EEE Improvements For Highly Sparse Traffic

> Saied Benyamin George Zimmerman

Modifications to the standard Slow Wake

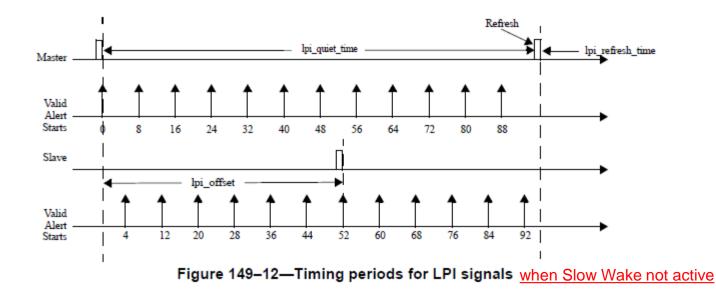
• Modify title of Figure 149-12 (defines Valid Alert start) as follows:

Figure 149-12a – Timing periods for LPI signals when Slow Wake is active

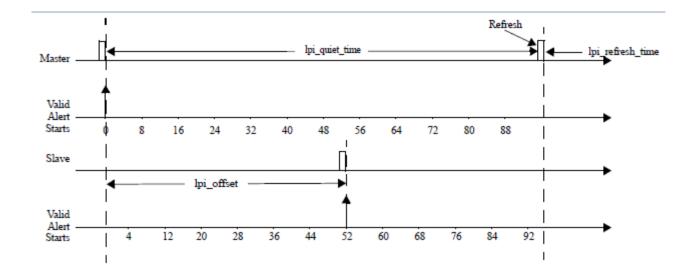
- Insert new figure after 149-12 for timing when slow wake is active
 - Change text references to LPI timing Figure 149-12 to say "Figure 149-12 and Figure 149-12a" (page 99 lines 11 and 51 – figure will be auto-numbered in the draft)
